# MELIADINE TYPE A WATER LICENSE CYTOGO ALTIC CALTY CALTY ALTIC ALTY

Public Hearings February 10-11, 2015, Rankin Inlet, NU ΔΔΔ<sup>c</sup> bnlncdσ<sup>c</sup> 6,2016 6,7%,2016 6,7%,2016

- This presentation accompanies our submission to the Nunavut Water Board on December 17, 2015
  - "R151217\_J150077\_Meliadine WL A Public Hearing Technical Submission"
  - That submission documents our concerns and resolutions as of the submission date
- Our review was comprised of 27 separate information requests and technical comments

#### KIA-WL-15: Sample Station Categorization

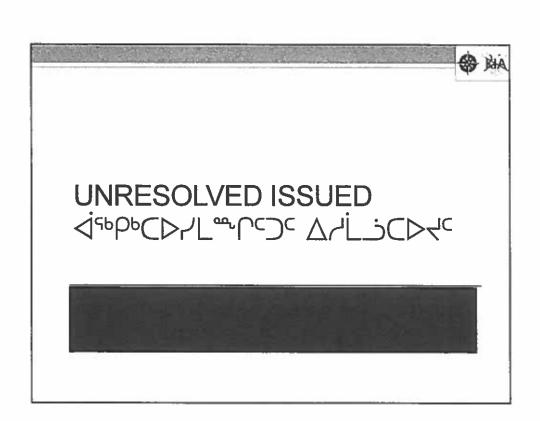
- AEM categorized MEL-05, MEL-06 and MEL-07 as "verification samples"
- Verification samples are "for operational and management purposes by Agnico Eagle"
- General Aquatic samples are
   "subject to compliance assessment
  to confirm sampling was carried out
  using established protocols,
  included quality assurance/quality
  control provisions, and addresses
  identified issues."
- KIA were concerned that these stations drain to Meliadine Lake and any problems detected should trigger management action

- The Nunavut Water Board prehearing decision report included a satisfactory commitment from AEM outlining:
  - Sampling frequency at MEL-05, MEL-06 and MEL-07,
  - Reporting requirements for those sites, and
  - The Low Action Level response framework should monitoring indicate changes in water quality at those locations
- We consider this issue resolved

#### KIA-WL-07: Mixing Zone Water Quality Monitoring

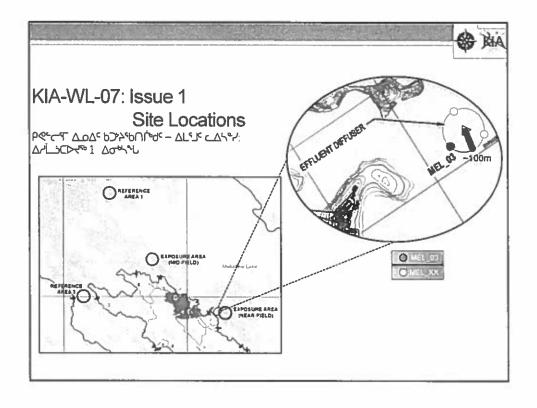
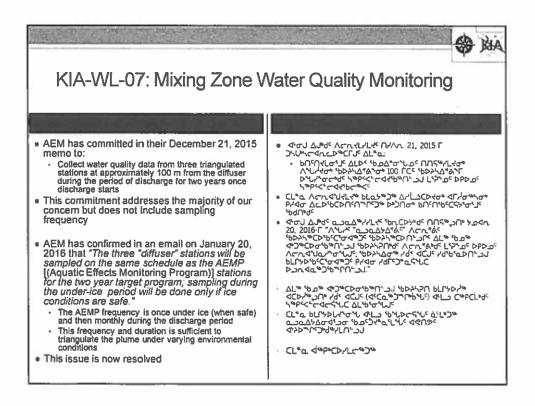
- AEM has proposed 5 sites in the near-field exposure area as part of the Aquatic Effects Monitoring Program, but no sites are proposed to triangulate effluent from the diffuser
- AEM has indicated
  - The plume will be characterized through a delineation study required through the Environmental Effect Monitoring (EEM) component of the Metal Mining Effluent Regulations (MMER)

- The focus of MMER and the associated Plume Delineation Study is ensuring that the effluent is not toxic to aquatic life
- The focus of our concern is to ensure the integrity of the receiving environment is maintained and the predictions presented in the Environmental Impact Statement are validated
- Concerns with relying on the EEM Plume Delineation study are:
  - Wind, flow and other mixing zone dynamics which vary over time limits its capacity to characterize the mixing zone and assimilative capacity of Meliadine Lake under all conditions
  - It may not provide sufficient data to compare the plume's behaviour with predictions from the Environmental Impact Statement

- We requested that AEM allocate 3 of the near-field exposure area sites around the diffuser to triangulate the predicted mixing zone boundary 100 m from the diffuser
  - i.e. sites at 120°, 240° and 360°, 100m from the center of the diffuser
  - Samples should be collected from the highest point of conductivity as determined by a water column profile
- ΤΟΡΥΓΩΣΟΥ ΑΙΦΟ
   ΔΕΙΘΕΝΑΙ ΑΙΦΟ
   ΑΠΑΙΝΑΙΚΑΙ ΑΙΦΟ
   <l>
   ΑΙΦΟ
   ΑΠΑΙΝΑΙΚΑΙ ΑΙΦΟ
   ΑΝΑΙΝΑΙΚ
  - ኮኃስቦጋJ Δσየኑዖዺታኈጋና 120°, 240°
     ላዜጋ 360° Γ 100ሾሮና ጭበላσ
     ኄዕዖት\Δ\*ልዕና

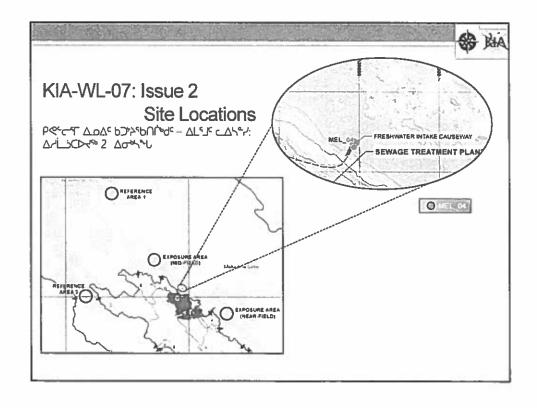
- The KIA is also concerned with tracking the effect of the effluent downstream of the diffuser in Baker Lake
- There is a significant proportion of Meliadine Lake that may be influenced by effluent but has no associated AEMP water quality stations
  - MEL\_04 is the only station in the "narrows" of Meliadine Lake

- The KIA and AEM have agreed to a resolution discussed via teleconference and presented in AEM's December 21, 2015 technical memorandum
- AEM has committed to a Low Action Level response to establish new water quality stations in the narrows if the plume is moving faster and farther than expected from the near-field exposure area
  - AEM clarified their definition of 'faster and further than expected' in an email on January 20, 2016 – comparison of water quality will be made to Environmental Impact Statement predictions, guidelines, benchmarks and baseline concentrations relying on the plume dispersion model generated through CORMIX
- This issue is now resolved
